UNITED STATES PATENT AND TRADEMARK OFFICE

10/540,292

Office Action Summary	Application No.	Applicant(s)	
	10/540,292	HAHN, THOMAS	
	Examiner	Art Unit	
	Philip Gabler	3637

DETAILED ACTION

Cullen et al. '238 Figures 3 and 5

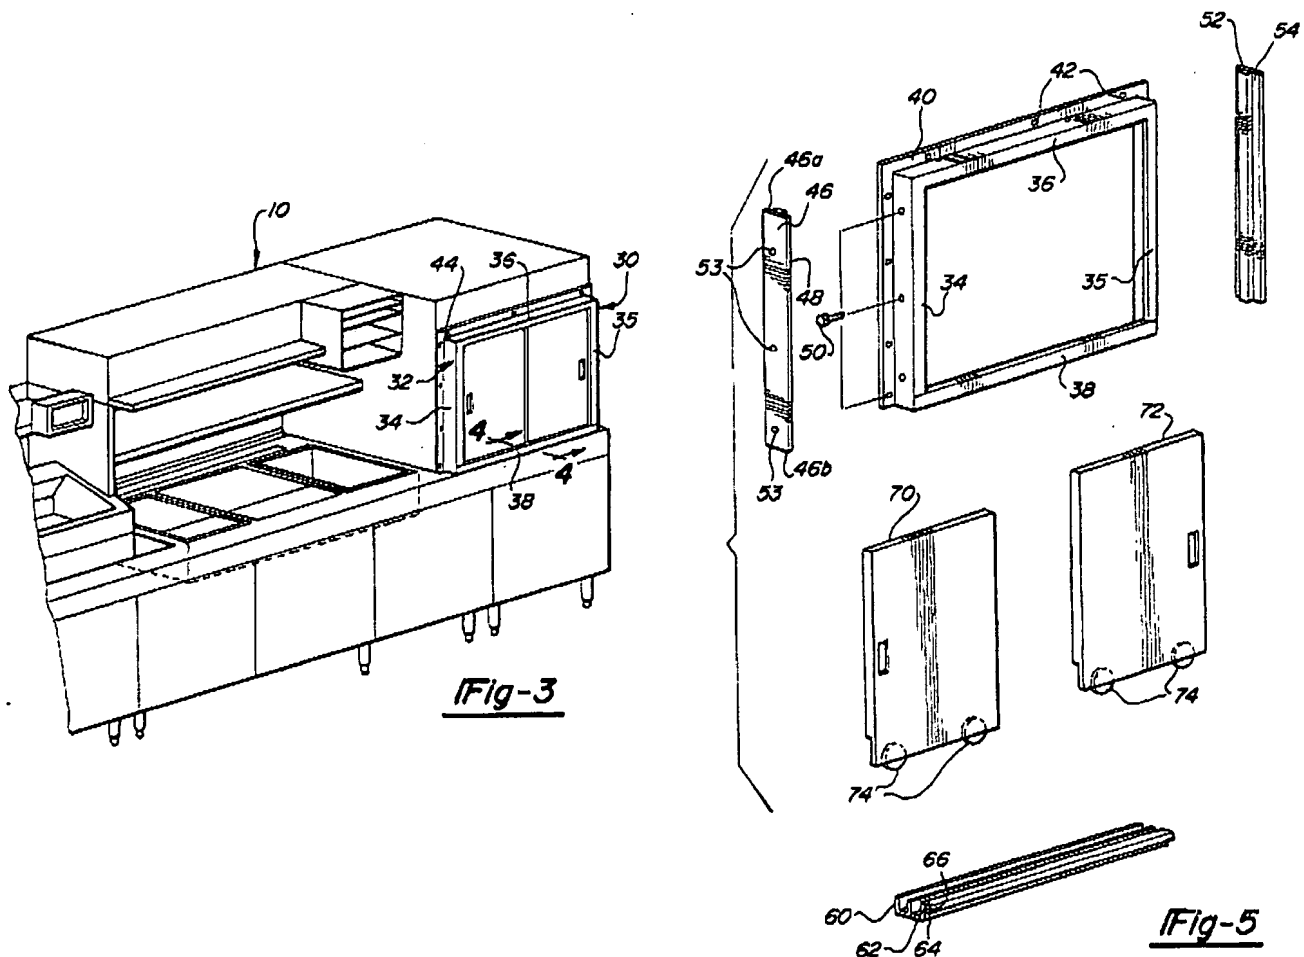
10. Claims 1-6 are rejected under 35 U.S.C. 103(a) as being unpatentable over Cullen et al. (US Patent Number 5853238) in view of Fenwick (US Patent Number 4148535). Cullen (Figures 3 and 5) discloses a cabinet for displaying objects, having several side panels, a base and an upper part that forms the top, at least one side panel being made in the form of a door (70), the outer side of which closes flush in the area of the outside edge of a side panel at the right- or left-hand side when the cabinet is in the closed state and the interior of the cabinet is sealed off from its surroundings in an airtight and dust-tight manner, appropriate flexible sealing strips (54, etc.) being affixed in the door's area of movement, wherein the door is mounted, by means of a guiding means (60, etc.) affixed in the top or the base or in both the top and the base (it is at least attached in the base), in such a way that it can be moved sideways in a parallel

manner in order to completely clear the door opening, whereby to open the door the relevant side panel (34) could be pushed back by suitable means, or the door can be moved forward by suitable means, to such an extent that the inner face of the door is able to pass the front edge of the side panel (the side panel could be moved to allow additional door motion). Cullen does not disclose a glass door. Fenwick discloses a cabinet with a sliding glass door (62). Accordingly, it would have been obvious to one of ordinary skill in the art at the time the invention was made to use a glass door in Cullen's device as taught by Fenwick because this would allow a user to view the contents of the cabinet without opening the door, adding convenience and further protection for the contents.

11. Regarding claims 2 and 3, Cullen, modified by Fenwick as described above, further discloses the side panel is mounted to the top or in the top and the base, and the door is permanently fixed by its guiding device to the cabinet (see figures).

12. Regarding claims 4 and 5, Cullen, modified by Fenwick as described above, further discloses sealing strips (54, etc.) affixed to the cabinet in the area of the side wall and at least one strip lies against the inner face or front edge of the door when the door is closed.

13. Regarding claim 6, Cullen, modified by Fenwick as described above, further discloses the door can be moved to both sides.

Shoffner '421 Figures 1 and 2

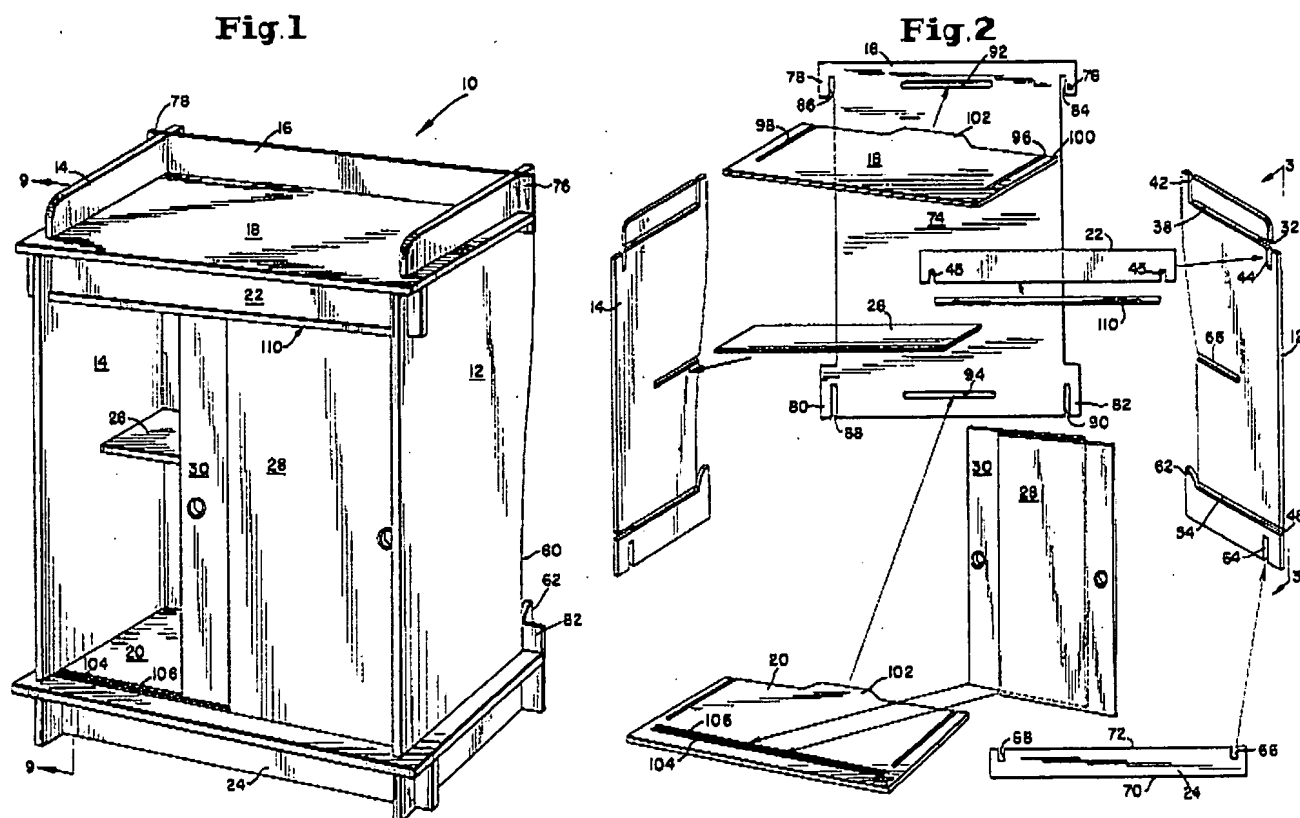
14. Claims 1-6 are rejected under 35 U.S.C. 103(a) as being unpatentable over Shoffner (US Patent Number 4832421) in view of Cullen and Fenwick. Shoffner (Figures 1 and 2) discloses a cabinet for displaying objects, having several side panels, a base and an upper part that forms the top, at least one side panel being made in the form of a door (30), the outer side of which closes flush in the area of the outside edge of a side panel at the right- or left-hand side when the cabinet is in the closed state and the interior of the cabinet is sealed off from its surroundings in an airtight and dust-tight

manner, wherein the door is mounted, by means of a guiding means (104, 106, etc.) affixed in the top or the base or in both the top and the base (it is at least attached in the base), in such a way that it can be moved sideways in a parallel manner in order to completely clear the door opening, whereby to open the door the relevant side panel (14) could be pushed back by suitable means, or the door can be moved forward by suitable means, to such an extent that the inner face of the door is able to pass the front edge of the side panel (the side panel could be moved to allow additional door motion). Shoffner does not disclose a glass door or a seal strip. Fenwick discloses a cabinet with a sliding glass door (62). Accordingly, it would have been obvious to one of ordinary skill in the art at the time the invention was made to use a glass door in Shoffner's device as taught by Fenwick because this would allow a user to view the contents of the cabinet without opening the door, adding convenience and further protection for the contents. Cullen discloses a cabinet having sealing strips (54, etc.) for sealing an area opened by a door. Accordingly, it would have been obvious to one of ordinary skill in the art at the time the invention was made to use sealing strips as taught by Cullen in Shoffner's device because these would help better seal the cabinet, helping to protect the contents held within the cabinet.

15. Regarding claims 2 and 3, Shoffner, modified as described above, further discloses the side panel is mounted to the top or in the top and the base, and the door is permanently fixed by its guiding device to the cabinet (see figures).

16. Regarding claims 4 and 5, Shoffner, modified as described above, further discloses sealing strips affixed to the cabinet in the area of the side wall and at least one strip lies against the inner face or front edge of the door when the door is closed.

17. Regarding claim 6, Shoffner, modified as described above, further discloses the door can be moved to both sides.
